Technical Bulletin		Model 6 Cyl.	Group 8
Subject New A/C Lines and Rubber Mounts		Part Identifier 8743/45	Number 9601

Models Affected: ***All 911 Carrera Model Years 1995 and 1996***
911 Turbo Model Year 1996

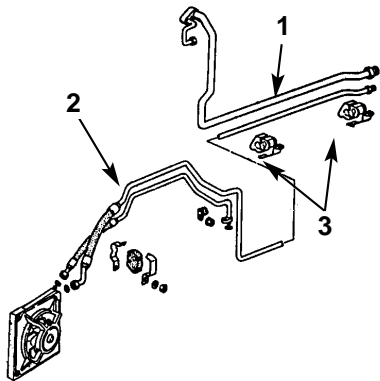
Concern: Corrosion on the A/C lines at the rubber mounts in the rocker panel area.

General Information: As of September 29, 1995, new version A/C lines and rubber mounts designed to prevent corrosion have been installed. The new lines have been installed as of the following VIN's:

Repair Information: Should replacement of the A/C line(s) become necessary, only the new version line(s) and mounts should be used. It is not necessary to replace both A/C lines unless both lines are leaking, however, replacement of both rubber mounts is necessary anytime either or both of the A/C lines require replacement.

Parts Information:	993 573 092 02	A/C line	Arrow 1
	993 573 107 02	A/C line	Arrow 2
	993 573 463 02	Mount (qty 2)	Arrow 3
